REC'D/MIDLAND
JAN 06 2020FORM APPROVED
OMB NO. 1004-0137
Expires: January 31, 2018**SUNDRY NOTICES AND REPORTS ON WELLS**
*Do not use this form for proposals to drill or to re-enter an abandoned well. Use form 3160-3 (APD) for such proposals.*5. Lease Serial No.
NMLC063875A

☐ Oil Well ☒ Gas Well ☐ Other8. Well Name and No.
POKER LAKE UNIT 27 BD 124H

XTO Permian Operating, LLC requests permission to make the following changes to the original APD:

DRILLING PLAN: BLM COMPLIANCE
(Supplement to BLM 3160-3)

13-3/8" x 9-5/8" x 5-1/2" 10M RSH-2 Wellhead
Assembly, With T-EBS-F Tubing Head

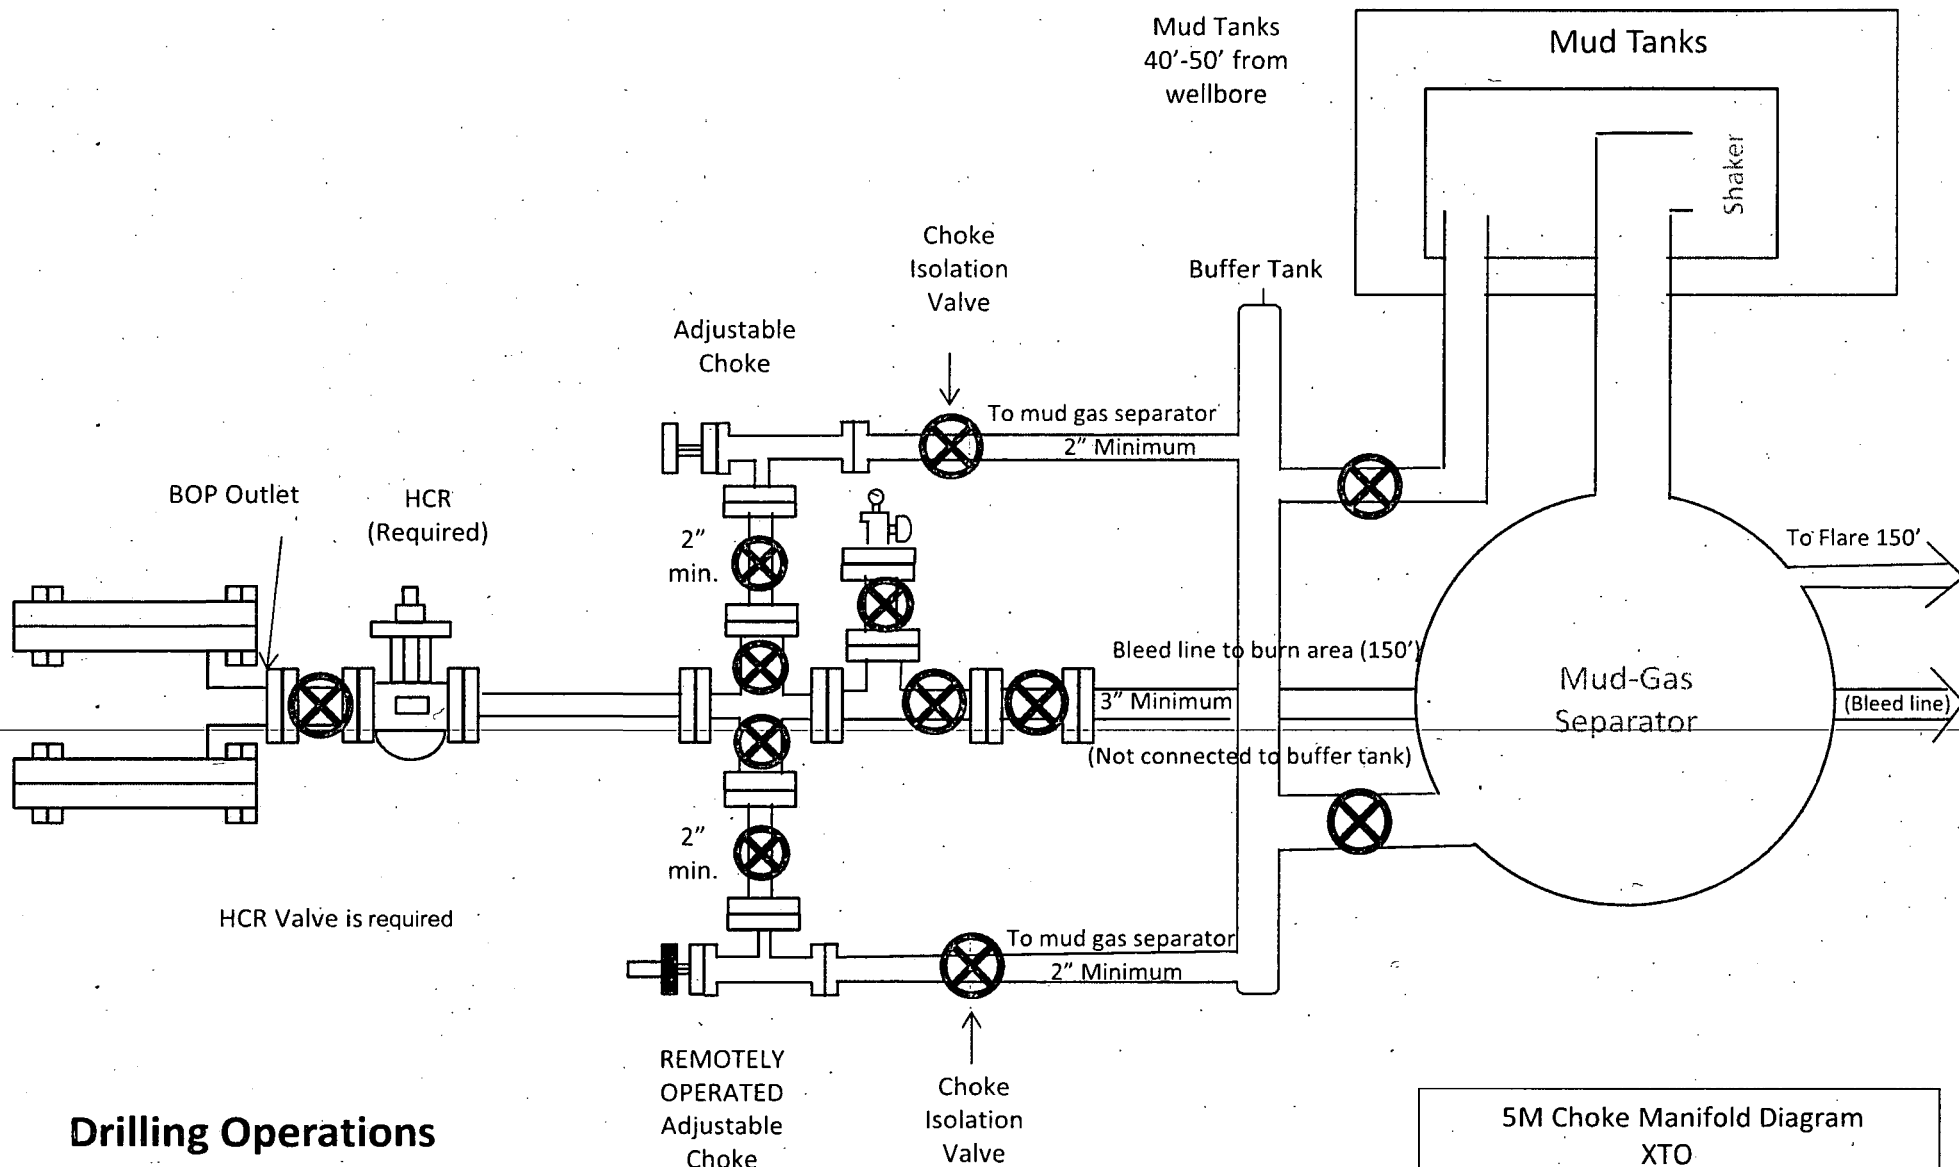
3. **Operator has proposed a multi-bowl wellhead assembly. This assembly will only be tested when installed on the surface casing. Minimum working pressure of the blowout preventer (BOP) and related equipment (BOPE) required for drilling below the surface casing shoe shall be 5000 (5M) psi.**

- a. **Wellhead shall be installed by manufacturer's representatives, submit documentation with subsequent sundry.**
 - b. **If the welding is performed by a third party, the manufacturer's representative shall monitor the temperature to verify that it does not exceed the maximum temperature of the seal.**

- c. **Manufacturer representative shall install the test plug for the initial BOP test.**
 - d. **Operator shall perform the intermediate casing integrity test to 70% of the casing burst. This will test the multi-bowl seals.**

- e. **If the cement does not circulate and one inch operations would have been possible with a standard wellhead, the well head shall be cut off, cementing operations performed and another wellhead installed.**

GRADE D PRESSURE TEST CERTIFICATE

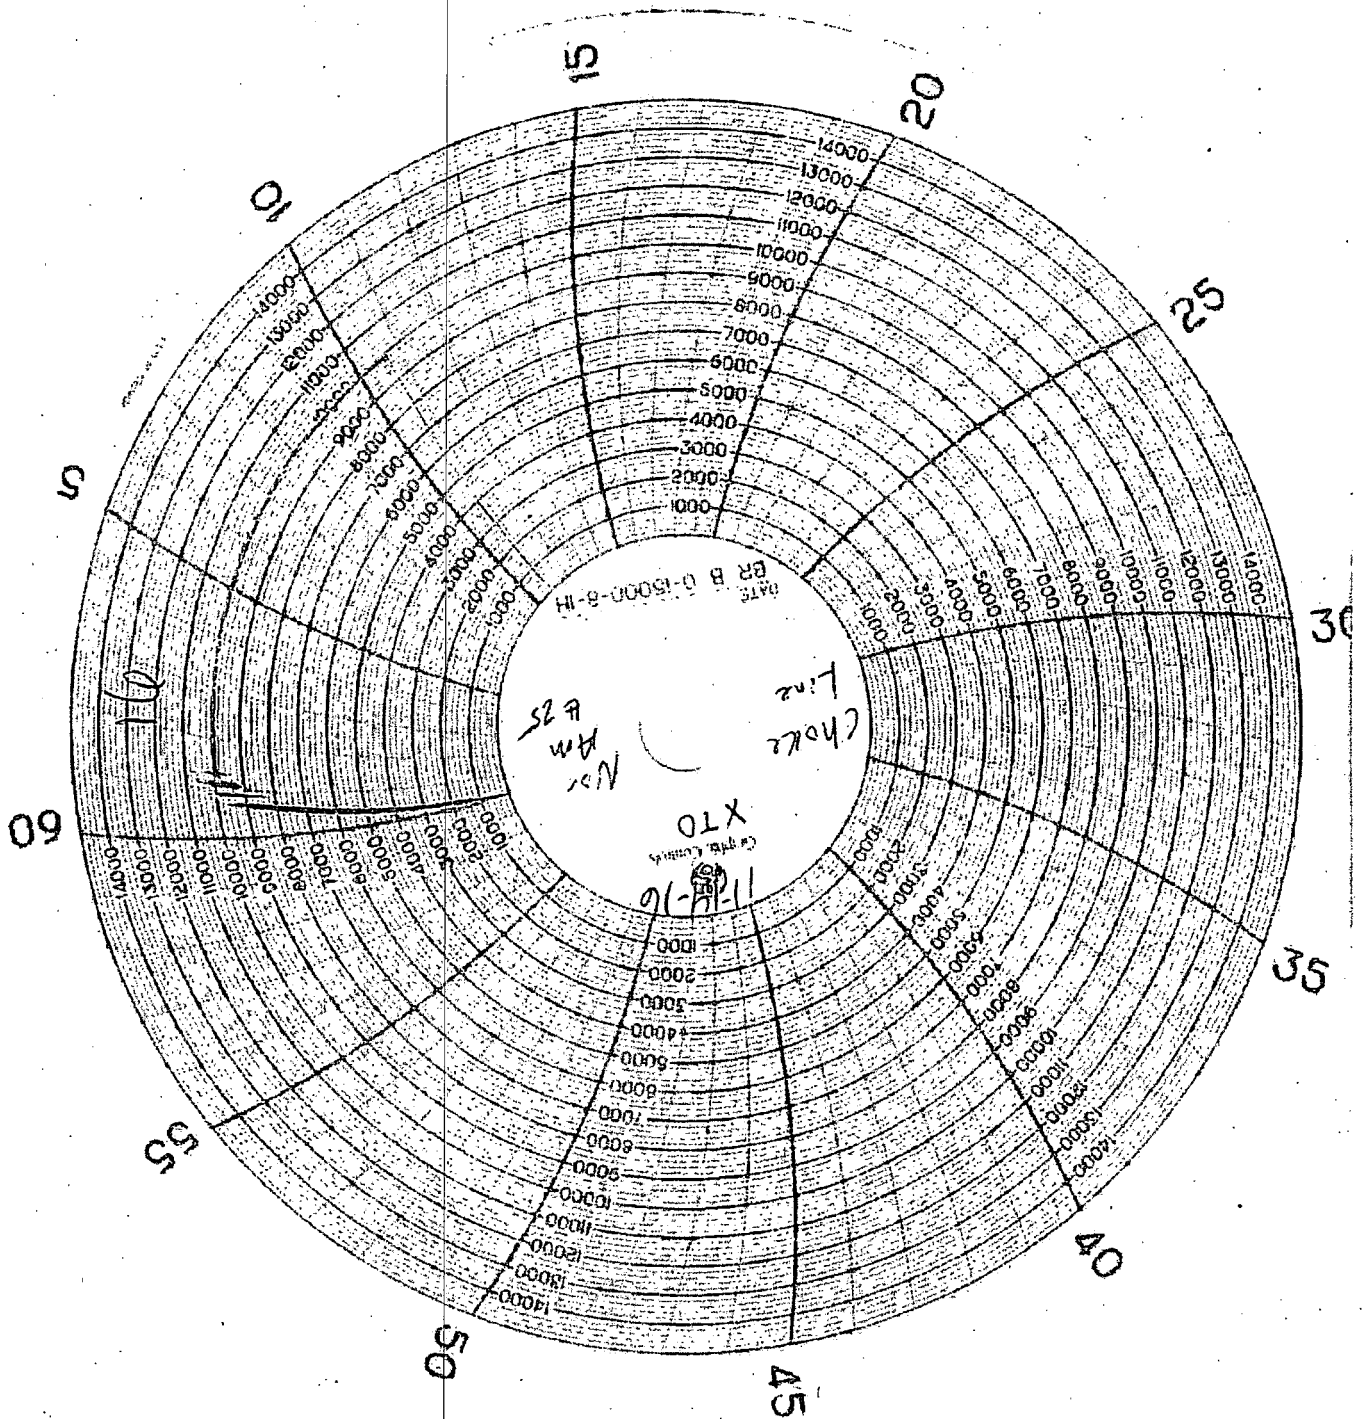
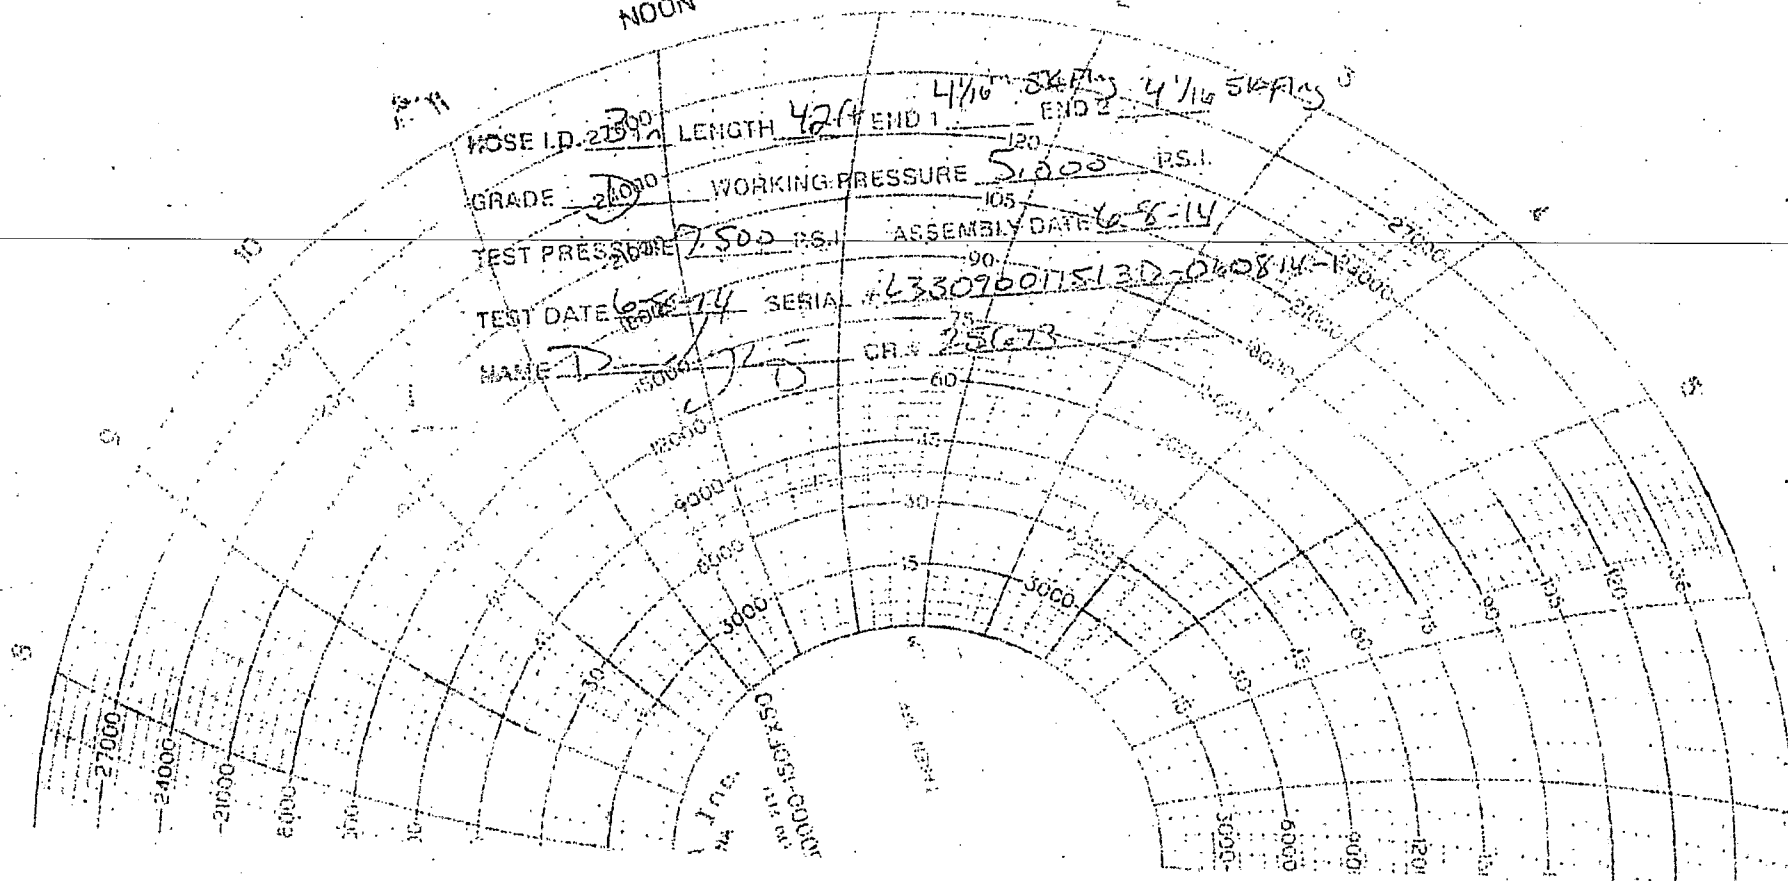
A variance is requested to allow use of a flex hose as the choke line from the BOP to the Choke Manifold. If this hose is used, a copy of the manufacturer's certification and pressure test chart will be kept on the rig. Attached is an example of a certification and pressure test chart. The manufacturer does not require anchors.

2. Variance approved to use flex line from BOP to choke manifold. Check condition of flexible line from BOP to choke manifold, replace if exterior is damaged or if line fails test. Line to be as straight as possible with no hard bends and is to be anchored according to Manufacturer's requirements. The flexible hose can be exchanged with a hose of equal size and equal or greater pressure rating. **Anchor requirements, specification sheet and hydrostatic pressure test certification matching the hose in service, to be onsite for review. These documents shall be posted in the company man's trailer and on the rig floor.** If the BLM inspector questions the straightness of the hose, a BLM engineer will be contacted and will review in the field or via picture supplied by inspector to determine if changes are required (operator shall expect delays if this occurs).
